## **URGENT Field Safety Notice**

**RE:** Addendum to the Instructions for Use (IFU) for Microstream Advance Intubated CO2 Filter Line, VitaLine Intubated CO2 Filter Line and FilterLine Intubated CO2 Filter Line

April 8<sup>th</sup> 2025

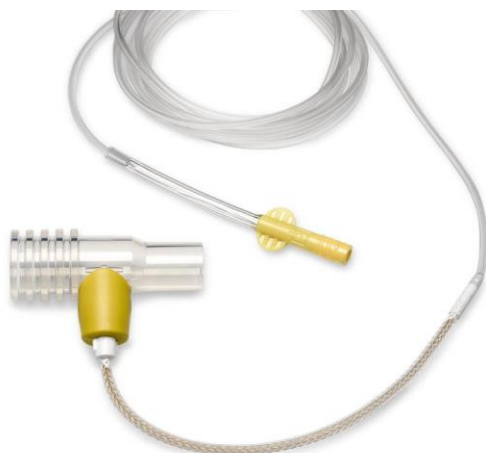
The inability to, or difficulty in disconnecting the adapter from the endotracheal tube to perform a procedure such as suctioning or administration of airway medication can result in an unintended extubation to perform the required procedure and/or a delay of treatment.

- Continue using the products following the instructions in IFU. During setup, ensure that the airway adapter can be easily attached and detached from the breathing circuit/tubing before proceeding. The airway adapter can be connected to the breathing circuit/tubing in a variety of configurations. These include a direct connection to the endotracheal tube.
- Pass this notice to all those who need to be aware within your organization or to any organization where affected devices have been potentially transferred.
- Complete the URGENT Field Safety Notice Response Form at the end of this notification to submit both acknowledgment of this URGENT Field Safety Notice and confirm understanding of actions to be taken.

- Following addendum to the IFU will be issued:  
*Adverse events associated with failure to follow the Instructions for Use while attaching and detaching the airway adapter from the breathing circuit are listed in descending order of severity: unintended extubation, respiratory failure, hypoxia, low oxygen saturation, aspiration/inhalation and delay to treatment. Any serious incident related to device use that may occur should be reported immediately to the manufacturer, the local competent authority, and any other regulators as required.*
